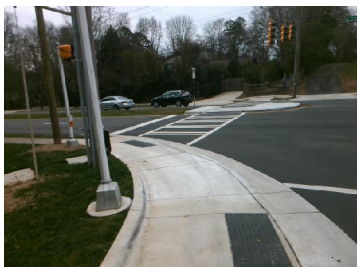
Possible Solutions: Remove & Replace
Replace APS Button With New APS Button.

PROW/ADA: R406.2, R404.7.3, R209.1,
MUTCD 4e.10
